1997 - 1998 Corvette: Service Bulletin: Loose Lower Front Fascia Valance Panels

Source: Chevrolet Dealer Service Bulletin

Number: 73-15-12A

SUBJECT: LOOSE LOWER FRONT FASCIA VALANCE PANELS (INSTALL ADDITIONAL ADDITIONAL WASHERS)

Figure 1

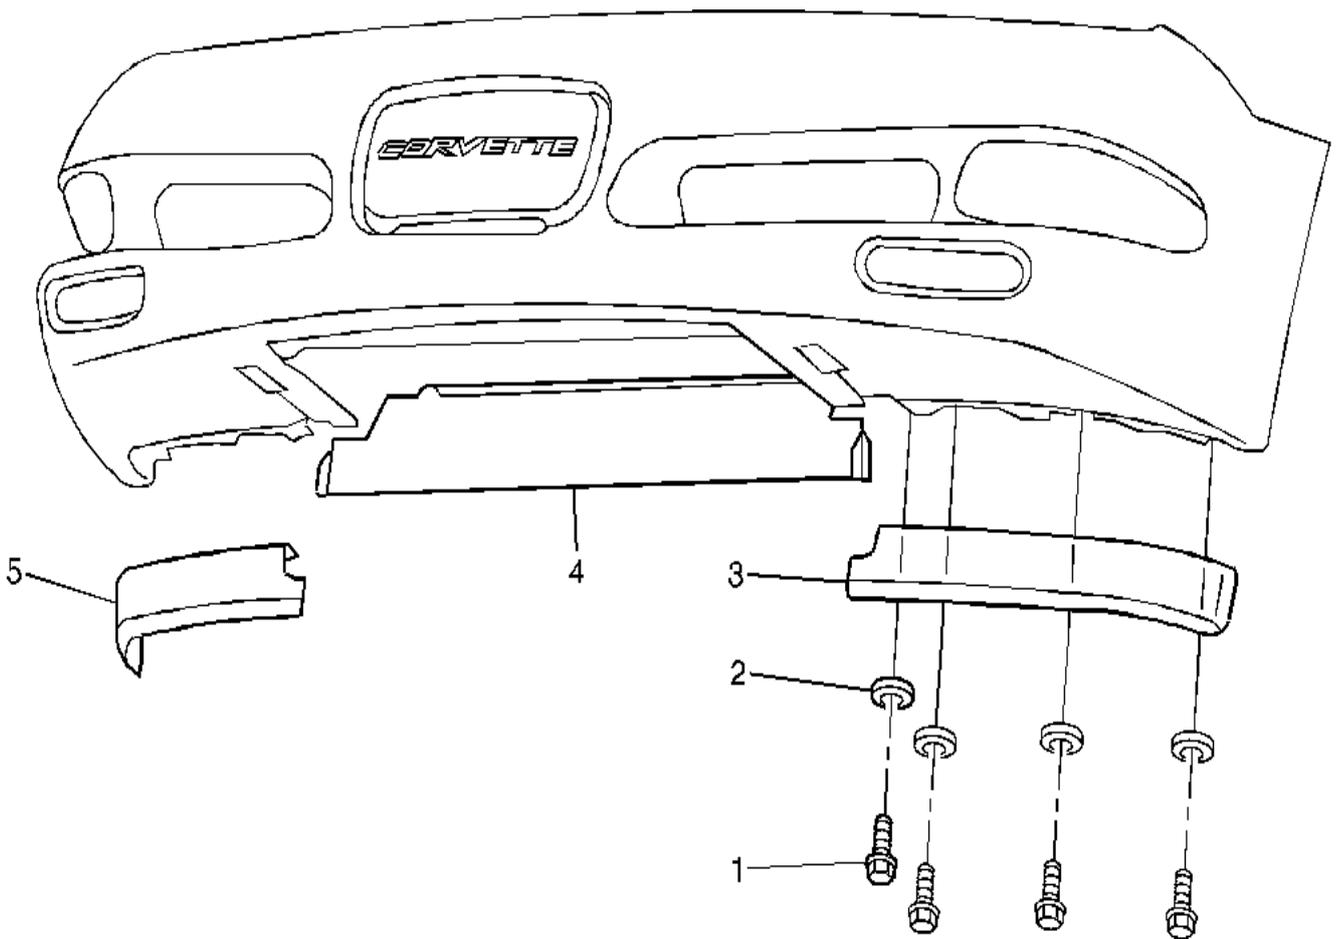
THE ORIGINAL WASHERS ON THE BOLTS/SCREWS THAT ATTACH THE LOWER VALANCE PANELS TO THE FRONT FASCIA MAY HAVE WORKED THEIR WAY THROUGH THE HOLES IN THE VALANCE PANELS.

ADD ONE ADDITIONAL LARGER FLAT WASHER, P/N 11500365, 25 MM O.D. BY 6.3 MM I.D. BY 2.5 MM THICK (1 IN. O.D. BY 1/4 IN. I.D. BY 3/32 IN. THICK) TO EACH OF THE EIGHT BOLTS/SCREWS (FOUR PER VALANCE PANEL) THAT ATTACH BOTH LOWER VALANCE PANELS TO THE FRONT FASCIA (SEE FIGURE 1). TIGHTEN BOLTS TO 7 N.M (62 LB IN).
